**SERVICE ADVISORY # 16-256**

Voltage Epic Series Quiet Cool

Keystone RV Company has determined that certain air conditioners installed in the main living area may not have been installed over the opening correctly resulting in a possible roof leak. This advisory explains the process to properly diagnose and remedy this concern.

**Fig. 1**

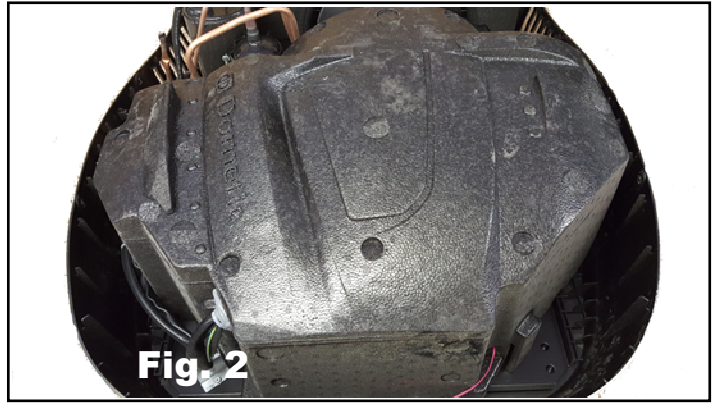
**Step 1.** Remove eight (8) screws securing the air conditioner shroud. See Fig. 1.

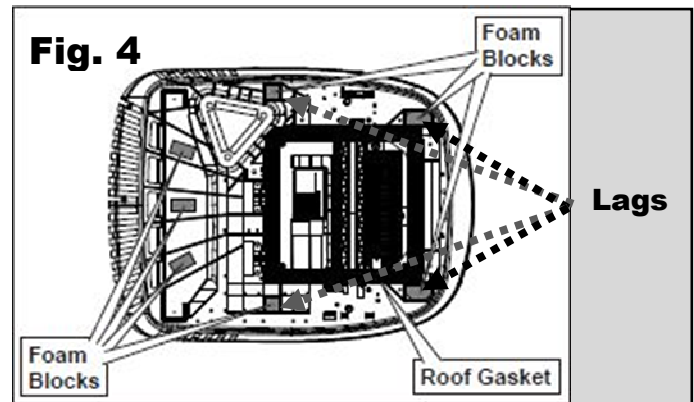
- A. Locate the interior fan and reach into the duct to the rear of the A/C. See Fig. 3.
- B. Feel the rear gasket and determine if it is sealing against the roof membrane. You may feel a gap between the 1 ½” gasket and the roof opening, feel the entire length of the gasket from door side to off door side, and front to back.
- C. If there is not a gap proceed to step 8.
- D. If there is a gap proceed to step 4.

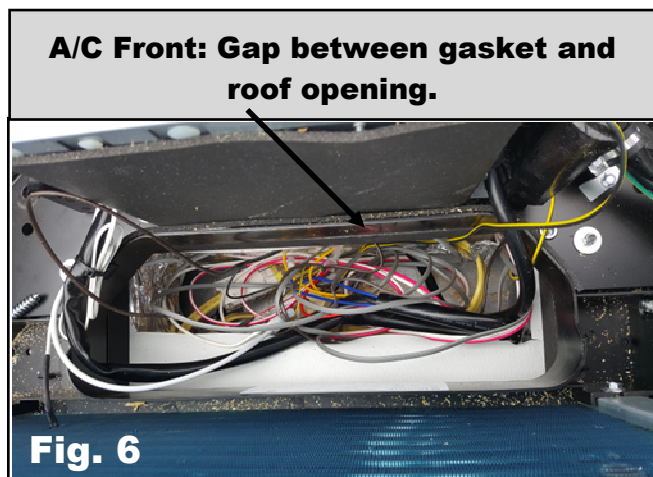
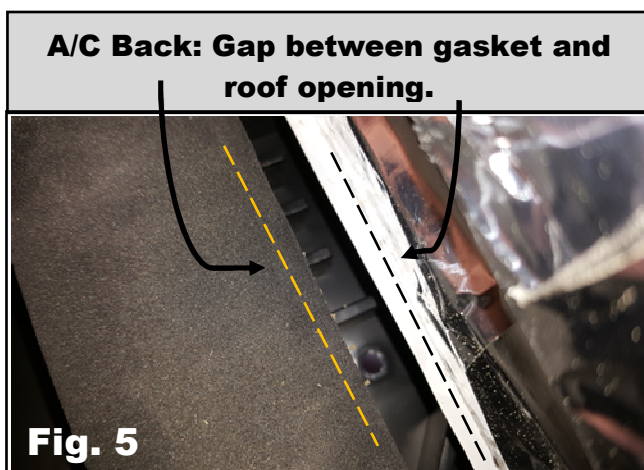
**Step 4.** Remove the four (4) lag screws securing the air conditioner to the roof. See Fig. 4

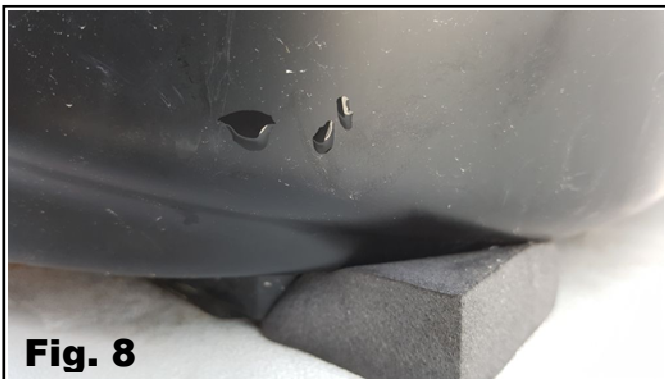
**Step 5.** Lift A/C, do not slide or gasket damage could occur, and move back so that the 1 ½” gasket is touching the roof at the front and the rear.

**Step 6.** Add sealant to the existing lag holes, Fig. 7, and cut a 2" piece of the supplied gasket to cover the old holes. See Fig. 8, 9
